DEPARTMENT OF ENERGY
Environmental Management Los Alamos Field Office (EM-LA)
Los Alamos, New Mexico 87544

EMLA-2021-BF114-02-001

Subject: Response to Amended Approval Letter for Drilling Work Plan for Chromium Groundwater Project Regional Aquifer Monitoring Well R-71 and Amended Approval Letter for Drilling Work Plan for Chromium Groundwater Project Regional Aquifer Monitoring Well R-72

Figure 1 Conceptualization of potential bias in data representativeness associated with different monitoring-well screen configurations

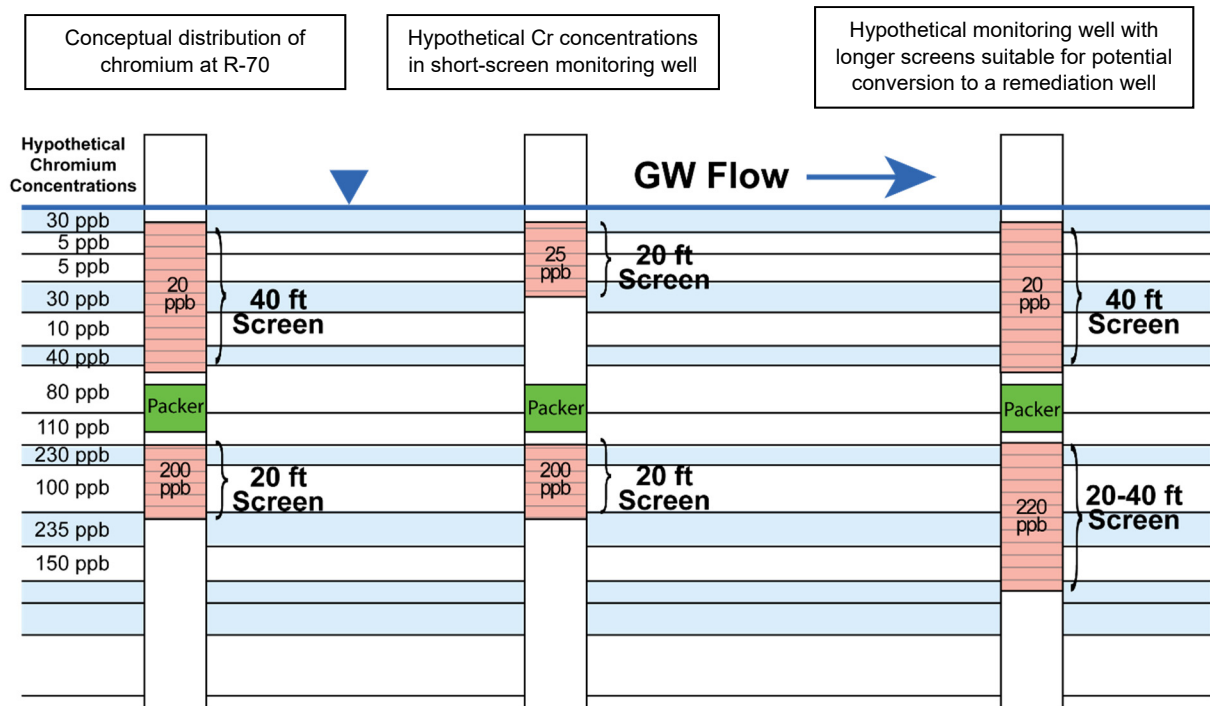
The Work Plan also specifies that NMED will approve the final well design at the time of drilling. Consequently, the final design was excluded from the March 26th approval letter. NMED is amending the approval of the Work Plan to specify that the screen lengths for R-71 must not be longer than 20 feet. This is because the excessively long screens proposed by DOE, to allow for repurposing later as part of remediation infrastructure, will negate the ability of R-71 to meet its primary objective.

- *U.S. EPA guidelines limit monitoring well screen lengths to between 2 feet and 20 feet.*
- *The highly layered nature of the regional aquifer geology mandates discrete sample intervals.*

- *The potential for sample dilution from the penetration of different geologic strata.*
- *The potential to spread contamination from one geologic stratum to other geologic strata.*

- *The potential for the sample to reflect conditions from a stratum of unknown stratigraphic position in the aquifer.*
- *The loss of the ability to compare its data to data from properly designed existing monitoring wells, specifically R-62 and R-43 (from R-71 amended approval).*

- *The potential to jeopardize the final remediation design by using misrepresented data.*
- *The suspect anomalous result obtained from screen 1 at R-70; the only repurpose well design with a screen exceeding 20 feet (screen 1 is 40 feet long).*

EM-LA believes that well screen lengths and other design attributes for R-71 and R-72 should be considered in the context of the project status and data quality objectives (DQOs). For the Chromium Project the key objective for wells R-71 and R-72 is to characterize and monitor specific areas of the plume. Key objectives include characterization of the vertical extent of contamination and collection of monitoring data that will inform the approach to remediation. Shorter screens may be appropriate for meeting the objective of characterizing vertical extent of contamination at both of these wells. However, longer screens may be suitable for generally characterizing integrated concentrations of chromium in areas of the plume that may be targeted for remediation since, as described below, remediation of the chromium plume is not likely to target short, relatively discrete intervals of the plume less than 20-ft thick.

During a technical team meeting held with NMED on September 10, 2020, EM-LA described that our analysis of the stratigraphy of unconsolidated units that compose the aquifer in the chromium plume area have led to an understanding that the highly stratified formations where the plume occurs function hydrologically as one hydrostratigraphic unit composed of thin (averaging approximately 1-ft thick) laterally discontinuous beds with varying hydraulic conductivity. Individual hydraulically conductive layers cannot be correlated between control points (wells), so plume-scale preferential flow is likely governed by multiple local intersects of hydraulically conductive layers that compose the dominant advective flow regime. Chromium flux at any location within the plume is therefore also expected to be occurring within a subset of beds distributed variably within the contaminated portion of the aquifer. Estimates from these high-resolution stratigraphic characterization studies indicate that preferential flow and mass chromium flux occur in approximately 50–60% of the total stratigraphic thickness of the plume.

To address the inherent local-scale uncertainty of the vertical distribution of higher hydraulic conductivity units and chromium concentrations, longer upper screens at R-71 and R-72 that integrate across thicker (30–40-ft) sections of the aquifer actually provide confidence that all potentially contaminated strata that are involved in advective flow and contaminant transport would be monitored. Although net concentrations of a constituent might be lower or higher from longer well screens at R-71 or R-72, what is most important in well-screen design from a DQO-based perspective is to characterize the vertical extent of chromium and to represent the general concentration and plume behavior of chromium at a given location since all locations with elevated chromium concentrations are likely targets for remediation. Shorter screens could easily result in a low bias in local chromium concentrations even if they are placed in units with the highest hydraulic conductivity. Figure 1 provides a hypothetical example of the potential bias in data representativeness from monitoring with short screens in the Chromium Project area, where it is not viable to monitor with a densely spaced well network with more discrete-horizon resolution. Attempts to identify and monitor the discrete strata with the maximum chromium concentration at a location (or for direct comparisons of chromium concentrations with R-62 and R-43 in the case of NMED's comment in the R-71 amended approval) are not necessary or useful for informing a remediation strategy since extraction and injection would not be limited to thin, targeted strata. Consistent with the general approach being used for the interim measure, the likely remediation approach for the chromium plume will be to address the inherent uncertainty of vertical chromium distribution at any given location by extracting and injecting across a greater thickness of aquifer that captures high hydraulic conductivity units within the chromium plume. Using that approach, extraction is likely to

access the strata with mass chromium flux as well as those with lower or negligible mass flux. Under this scenario, monitoring-well screens at R-71 and R-72 that span a similar thickness to that target for remediation are preferred over shorter screens that may not provide samples representative of the overall plume response.

Blue shading indicates high-conductivity beds.

Beds within the stratigraphic sequence are approximately 1-ft thick on average; therefore, any screen, whether 10 ft or 40 ft in length, represents composite chromium concentrations. Beds in the figure are shown as thicker than 1 ft for conceptual purposes.

The general vertical distribution of chromium concentrations (e.g., generally lower in the upper portion of the aquifer and higher in the lower portion of the aquifer) is successfully characterized by both short and long screens.

Broad characterization is better for understanding how to design and implement remedial strategies, especially given that no single or small group of conductive beds is present that would be uniquely targeted for remediation.

Longer screens make it more likely that the well screen will include a number of conductive beds, and therefore the data will be more broadly indicative of conditions in the aquifer. Longer screens also ensure that if the well is repurposed for extraction or injection, a greater percentage of the total thickness of contaminated groundwater will be accessed for remediation.
